ADDENDUM NO. 2
TO
CONTRACT DOCUMENTS
FOR
CITY OF MANISTIQUE
MARINA RENOVATION PROJECT – PHASE II

JULY 13, 2018

This Addendum No. 2 consists of 32 pages.

Page has been reduced, not to scale.
Sheet 2013-S2
Addendum No. 2
Page 32 of 32

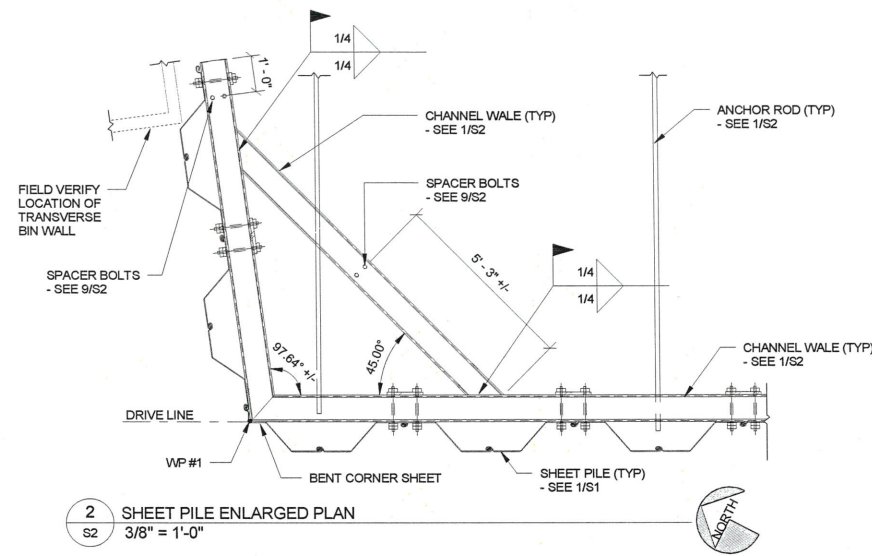
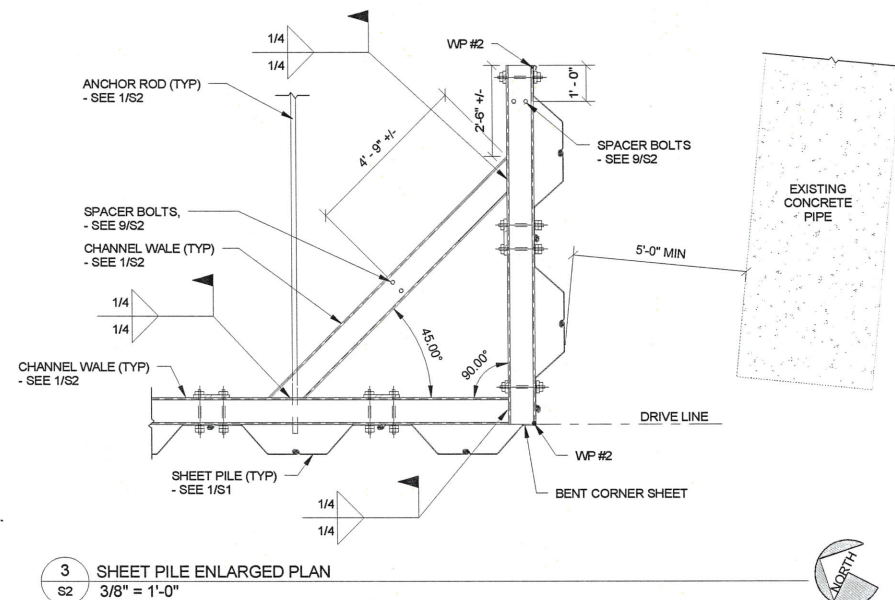
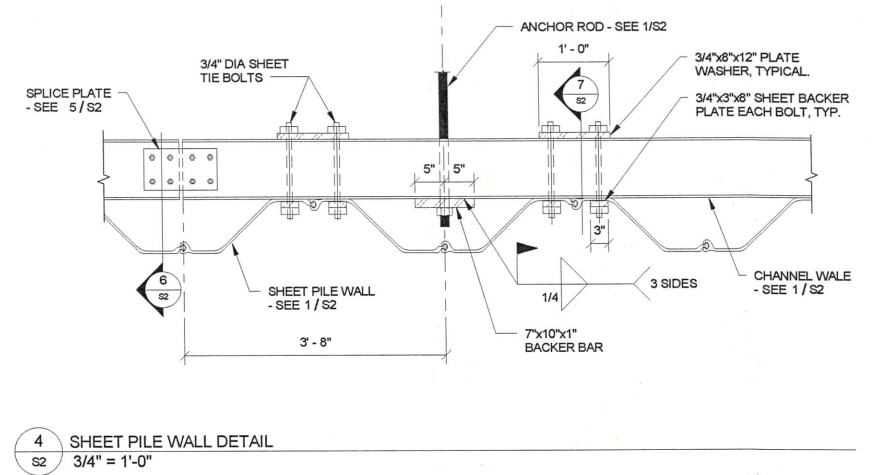
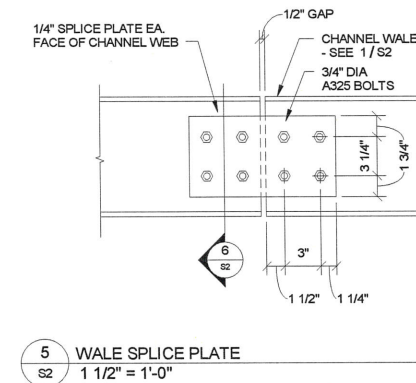
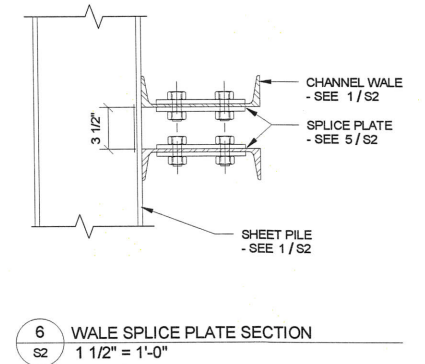
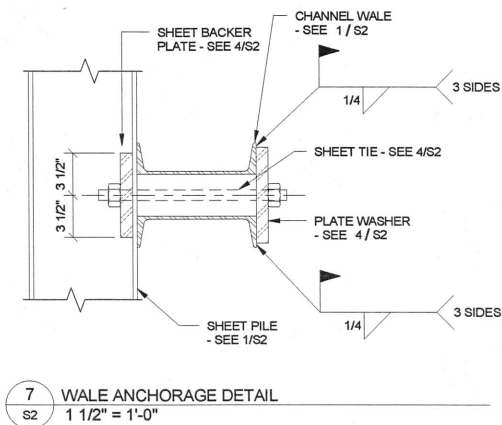
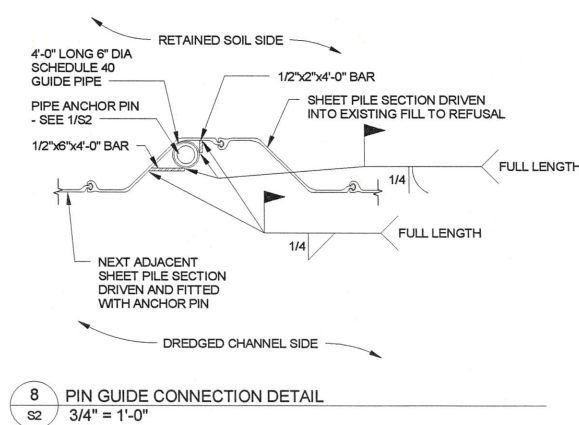
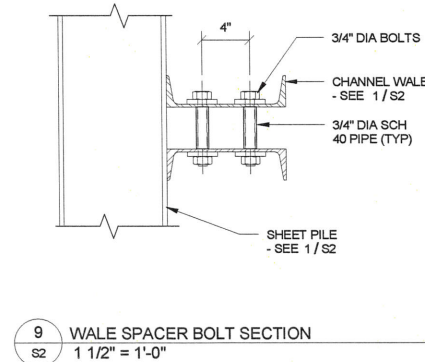
1. Plans Sheet S3: The dimension of 3’-8” shown on Sheet Pile Wall Detail 6/S3 should be 4’-9” (57”) center to center.
2. Plan Sheet S1: Under General Structural Notes – Rock Anchors, change, “*Anchor rods to be hot dip galvanized per ASTM A-153, min. thickness to be 3 mils.*” to “**Rock anchors** to be hot dip galvanized per ASTM A-153, min. thickness to be 3 mils.”
3. Plan Sheet S3: Detail 1/S3 – the sheet pile wall cap should read 15” channel cap instead of ¼” bent plate cap.
4. Plan Sheet S2 from the 2103 Marina Project (2103-S2) has been added to this addendum as a reference. Detail 3/S2 shows a typical corner section. This detail may be used for bidding purposes as an arrangement for the siphon bump-out corners.
